DUKE POWER COMPANY  
OCONEE NUCLEAR STATION

ATTACHMENT 1  
TECHNICAL SPECIFICATIONS

This section provides the technical justification for the proposed modifications to the ONS Technical Specifications. These changes revise certain Design Features specifications to address two new fuel designs, increase the initial fuel enrichment, and establish restricted loading patterns and associated burnup criteria for qualifying fuel in both Spent Fuel Pools at the Oconee Nuclear Station. These changes are necessary to allow storage and irradiation of fuel for the upcoming Unit 3 Cycle 16 reload core. These changes will also increase design and operational flexibility, while at the same time maintaining acceptable criticality safety margins and decay heat removal capabilities. In addition, several administrative changes have been included in order to provide clarity to the Specifications and bring them more in line with the NUREG-1430 B&W Standard Technical Specification (STS) format. A description of each of the changes being requested is given below.

Table 3.8-1

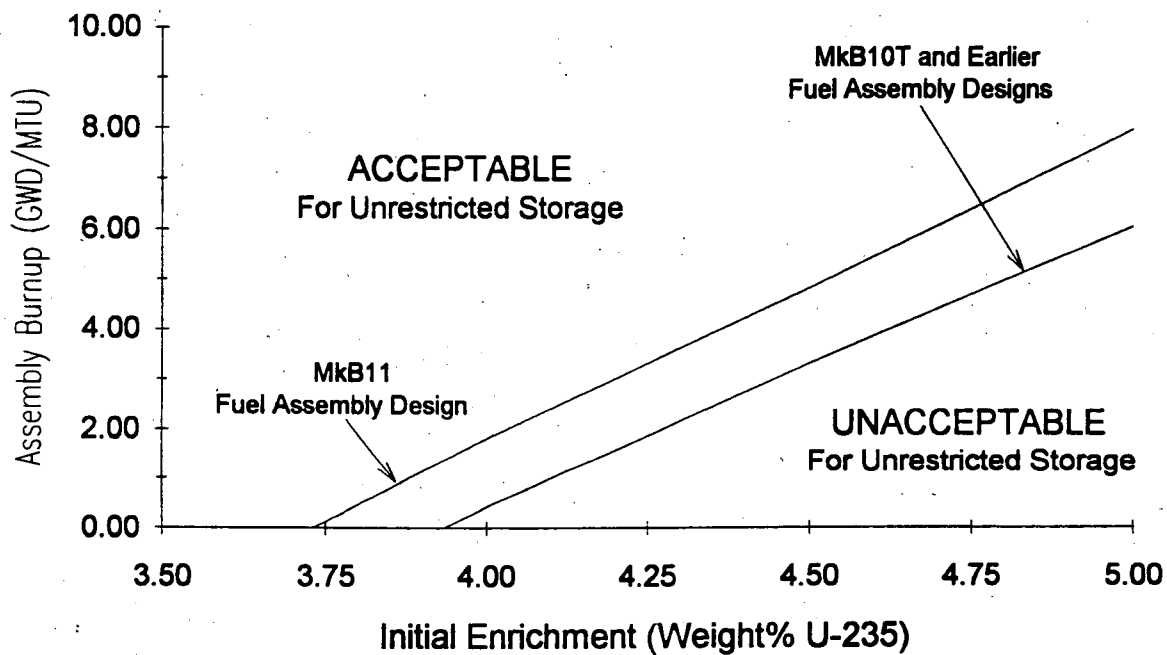
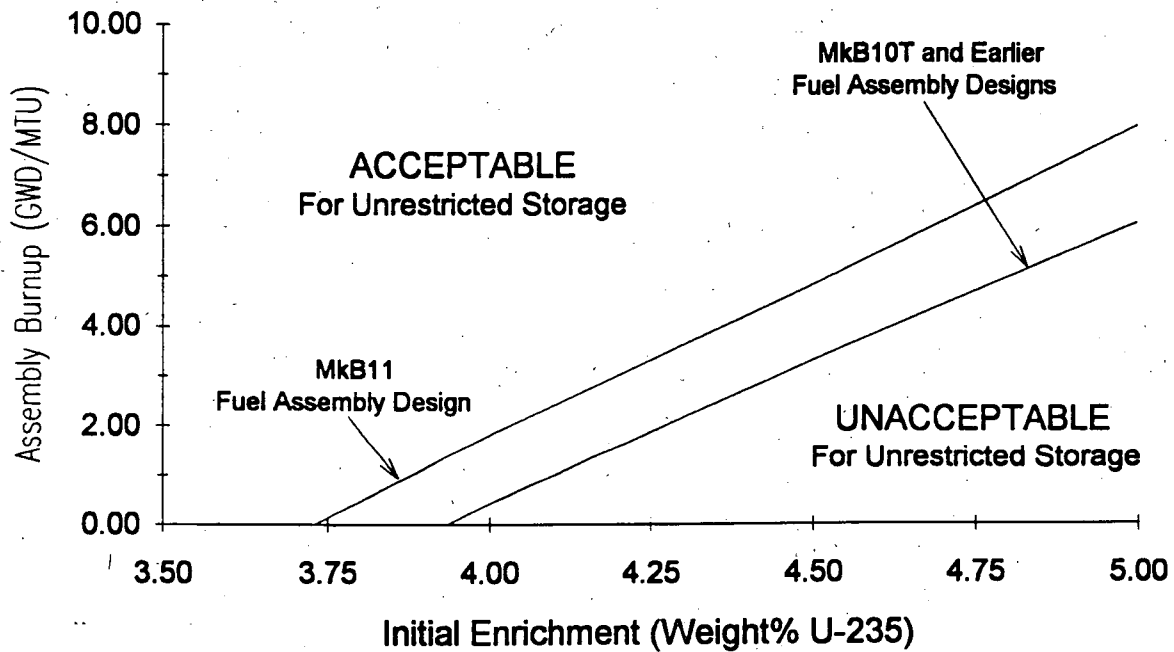
- 1). Unrestricted storage of fuel meeting the criteria of Table 3.8-1; or
- 2). Restricted storage in accordance with Figure 3.8-1, of fuel which does not meet the criteria of Table 3.8-1; or
- 3). Another configuration determined to be acceptable by means of an analysis to assure that  $k_{eff}$  is less than or equal to 0.95.

2. The Technical Specification List of Tables and List of Figures is being changed to add Tables 3.8-1 through 3.8-4, and Figures 3.8-1 and 3.8-2 which are both part of the new Specification 3.8.16 (see number 4 below). This change is purely administrative.

MkB10T and Earlier Fuel Assembly Designs		MkB11 Fuel Assembly Design	
<u>Initial Enrichment Weight% U-235</u>	<u>Assembly Burnup (GWD/MTU)</u>	<u>Initial Enrichment Weight% U-235</u>	<u>Assembly Burnup (GWD/MTU)</u>
3.93 (or less)	0	3.73 (or less)	0
4.00	0.43	4.00	1.83
4.50	3.30	4.50	4.80
5.00	6.03	5.00	7.95

Table 3.8-2

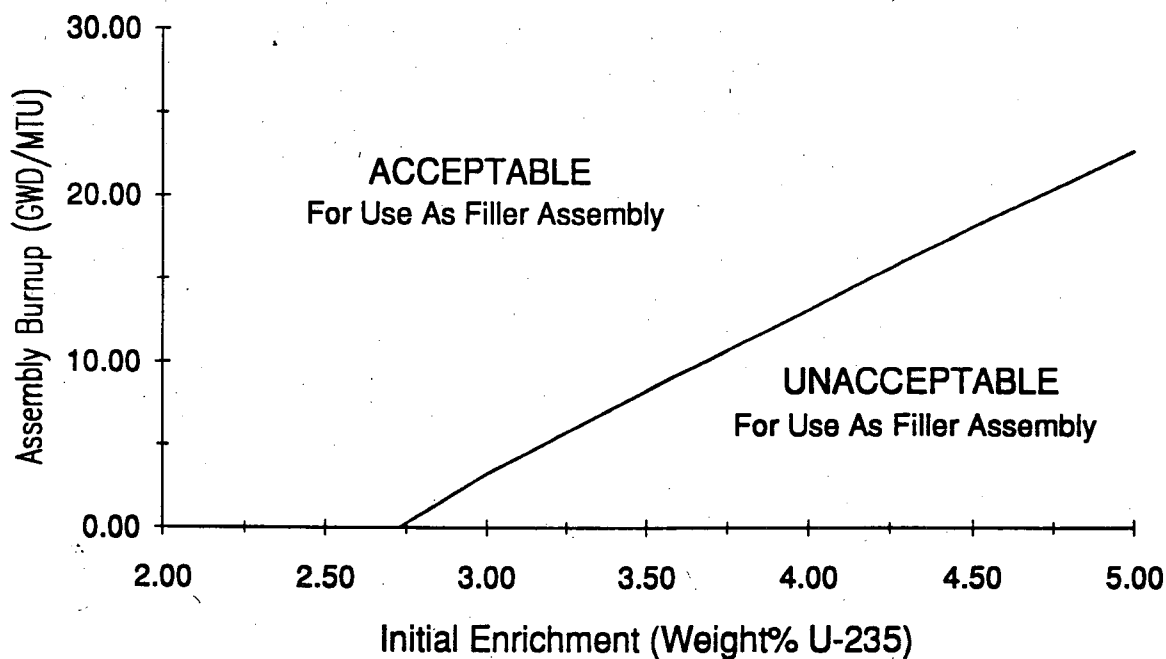
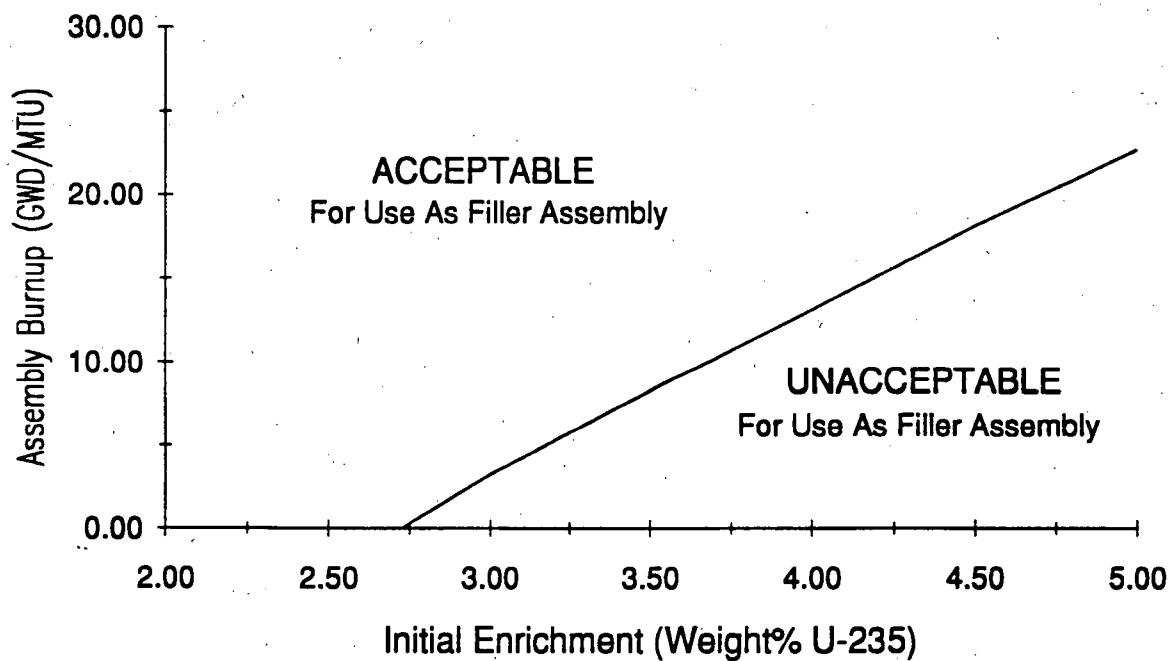
Either fuel which meets the minimum burnup requirements of Table 3.8-2, or an empty cell.

All Fuel Assembly Designs	
Initial Enrichment <u>Weight% U-235</u>	Assembly Burnup <u>(GWD/MTU)</u>
2.72 (or less)	0
3.00	3.25
3.50	8.22
4.00	13.13
4.50	18.10
5.00	22.69

Table 3.8-3

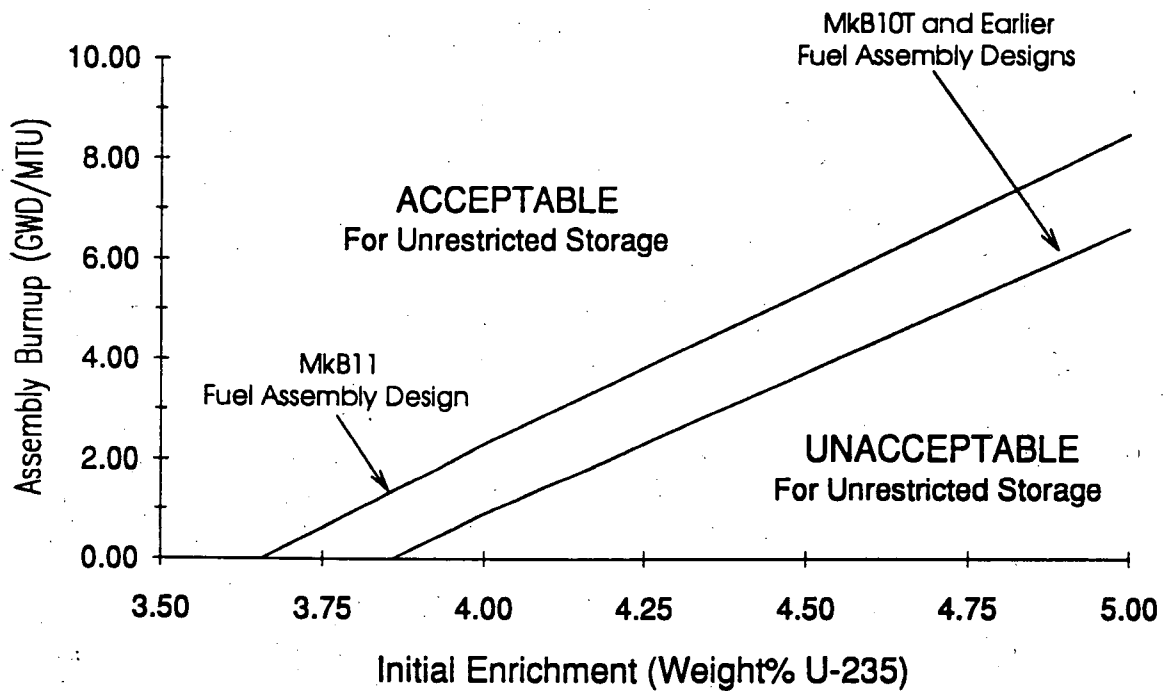
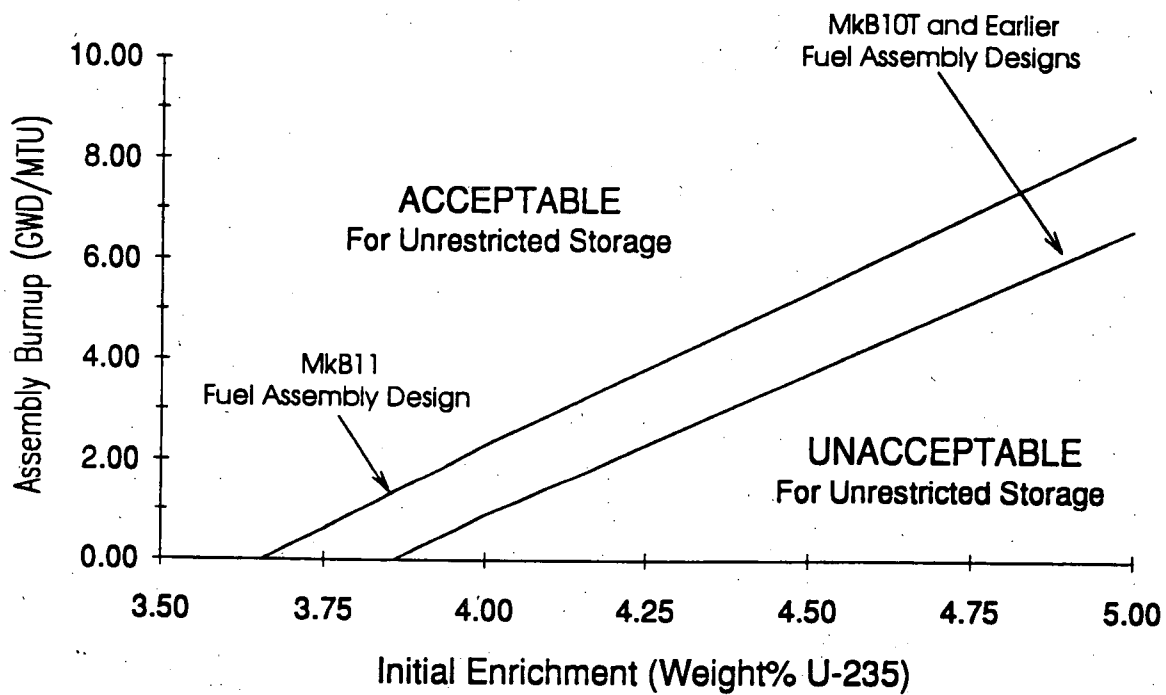
- 1). Unrestricted storage of fuel meeting the criteria of Table 3.8-3; or
- 2). Restricted storage in accordance with Figure 3.8-2, of fuel which does not meet the criteria of Table 3.8-3; or
- 3). Another configuration determined to be acceptable by means of an analysis to assure that  $k_{eff}$  is less than or equal to 0.95.

MkB10T and Earlier Fuel Assembly Designs		MkB11 Fuel Assembly Design	
Initial Enrichment <u>Weight% U-235</u>	Assembly Burnup <u>(GWD/MTU)</u>	Initial Enrichment <u>Weight% U-235</u>	Assembly Burnup <u>(GWD/MTU)</u>
3.86 (or less)	0	3.66 (or less)	0
4.00	0.91	4.00	2.31
4.50	3.73	4.50	5.34
5.00	6.60	5.00	8.49

Table 3.8-4

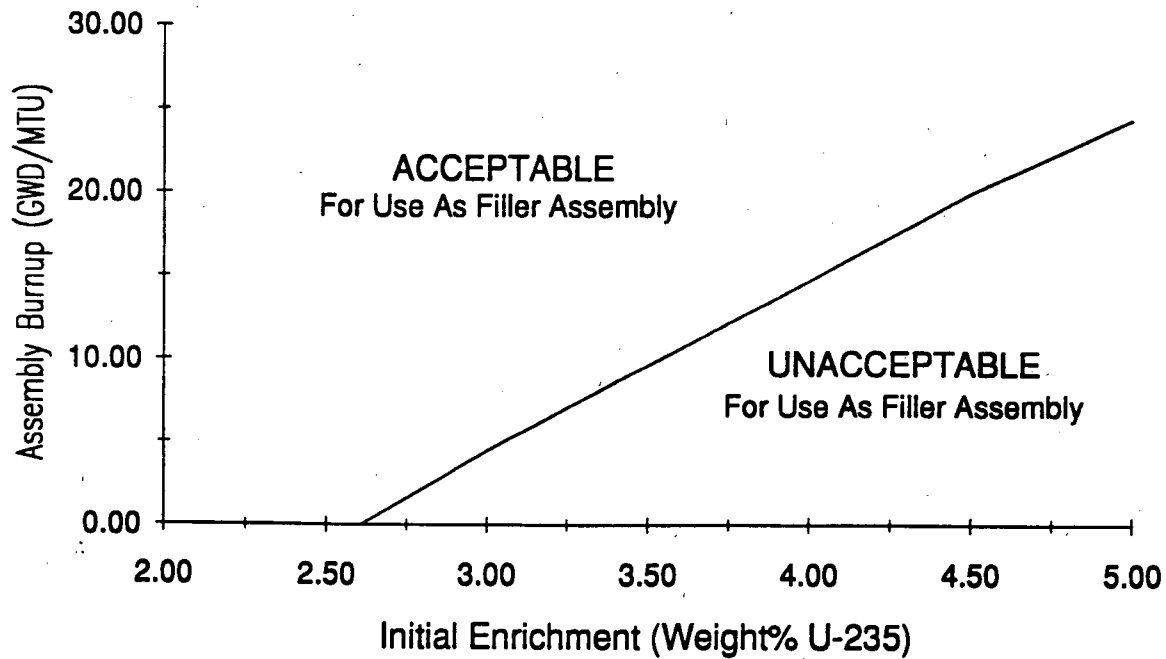
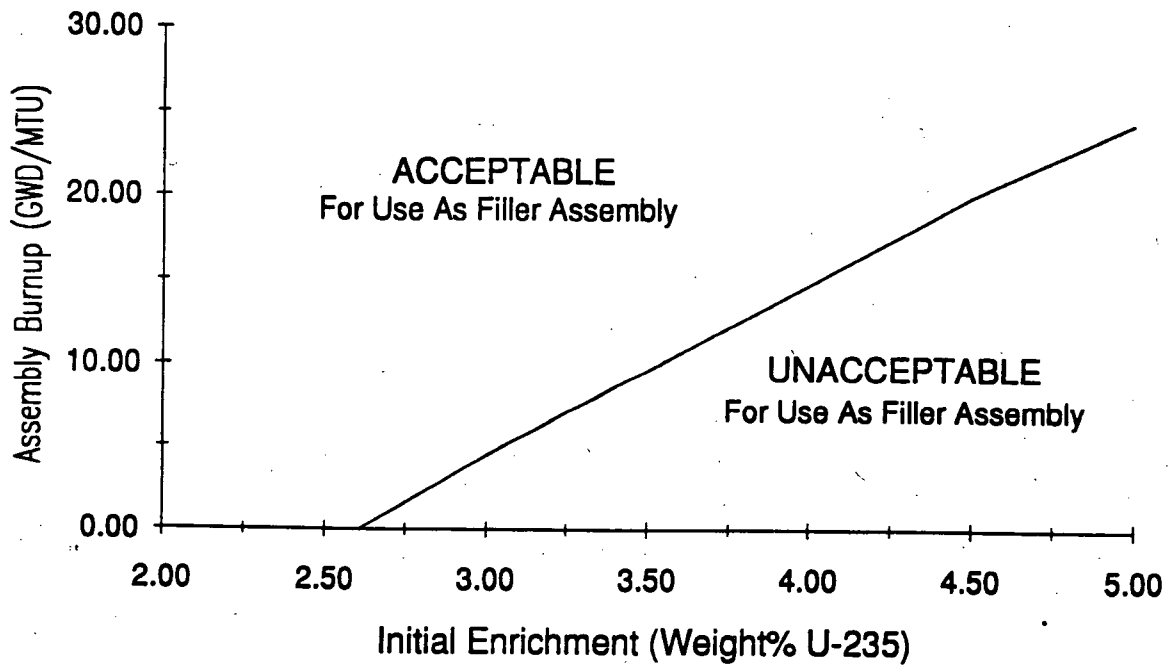
**Filler Location:** Either fuel which meets the minimum burnup requirements of Table 3.8-4, or an empty cell.

All Fuel Assembly Designs	
Initial Enrichment <u>Weight% U-235</u>	Assembly Burnup <u>(GWD/MTU)</u>
2.61 (or less)	0
3.00	4.49
3.50	9.62
4.00	14.68
4.50	19.96
5.00	24.37

Figure 3.8-1

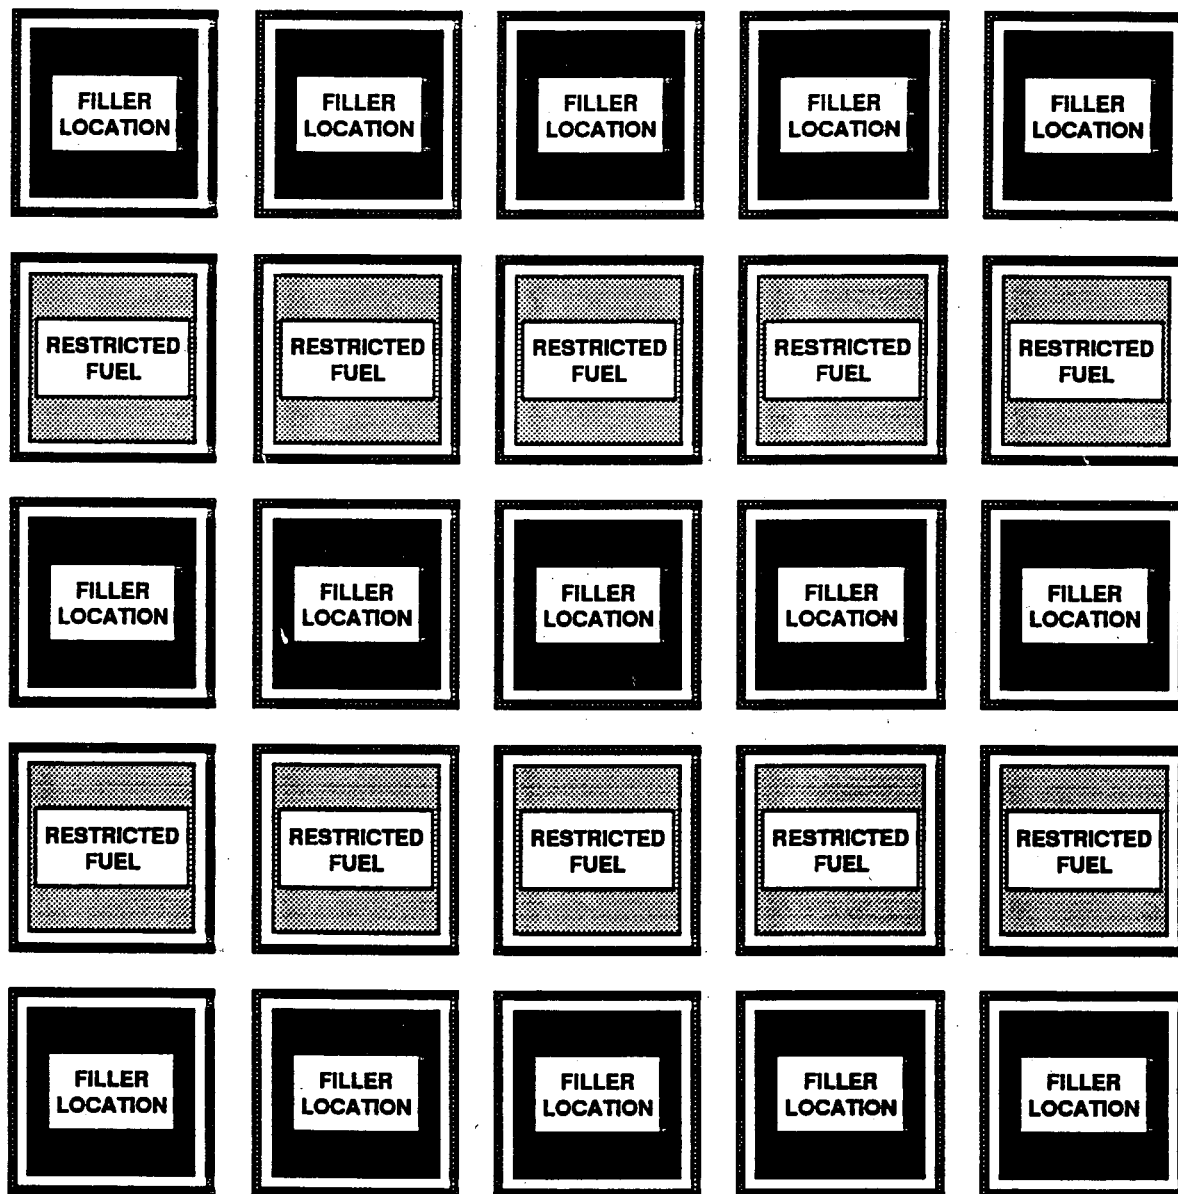
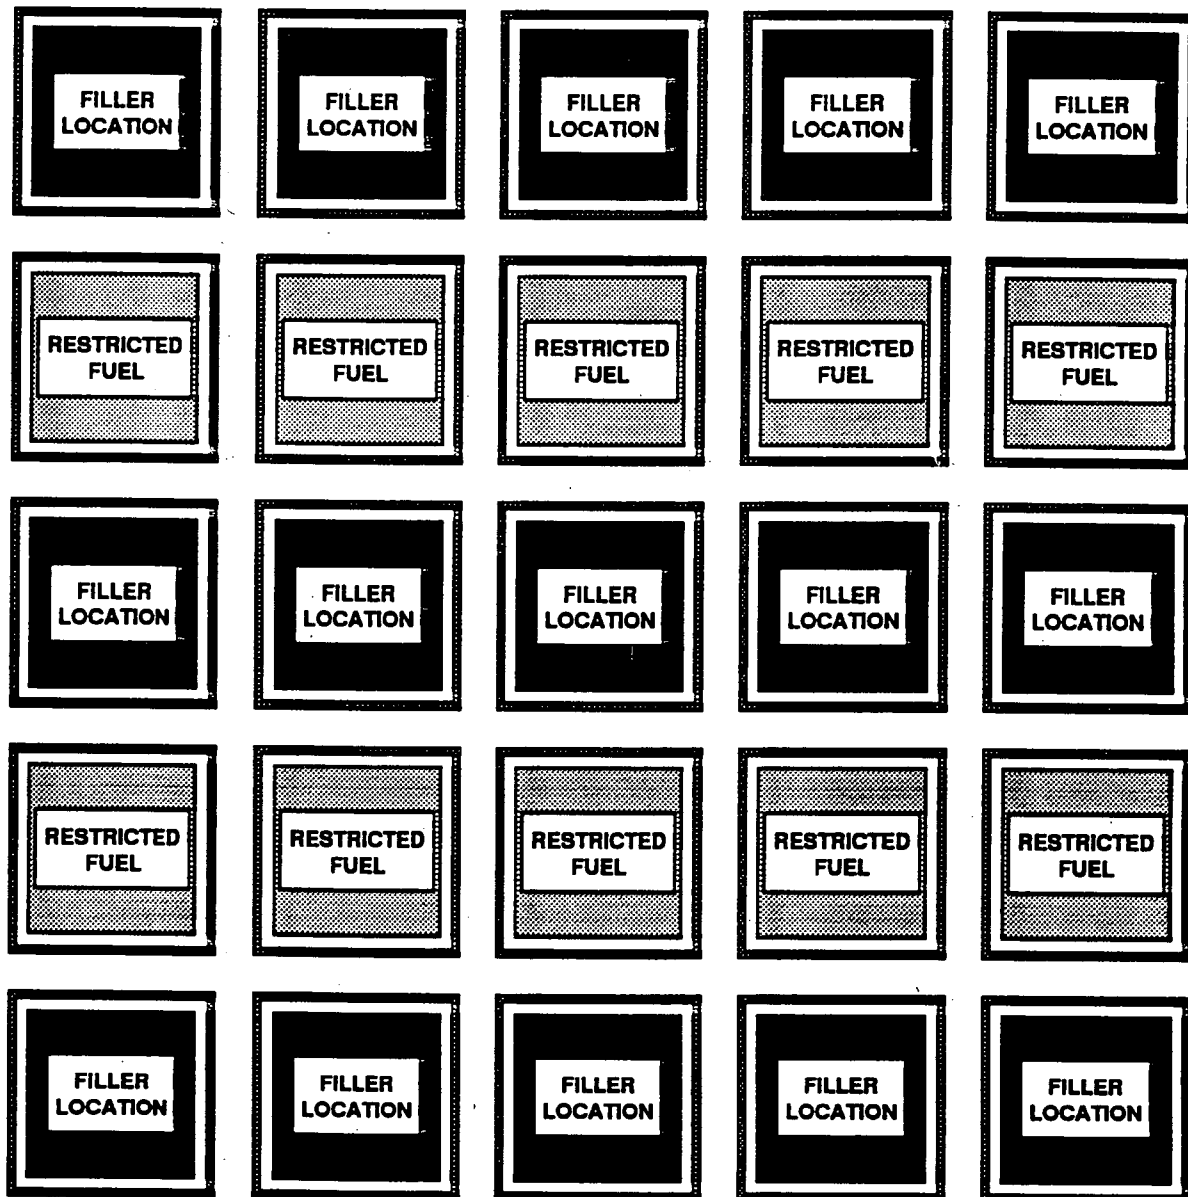
4. Specification 3.8.15 (fuel enrichment) is being replaced with Specifications 3.8.15 (Spent Fuel Pool boron concentration), 3.8.16 (fuel storage), and 3.8.17 (action statements). These changes are being made in order to accommodate the added Spent Fuel Pool (SFP) storage restrictions and to provide increased operational flexibility. This change also provides more consistency with STS format.

Fuel which does not meet the minimum burnup requirements of Table 3.8-1. (Fuel which does meet the requirements of Table 3.8-1 may be placed in restricted fuel locations as needed)

Any row bounded by an Unrestricted Storage Area shall contain a row of filler locations (i.e. A row of Restricted fuel assemblies may not be adjacent to a row of Unrestricted fuel assemblies).
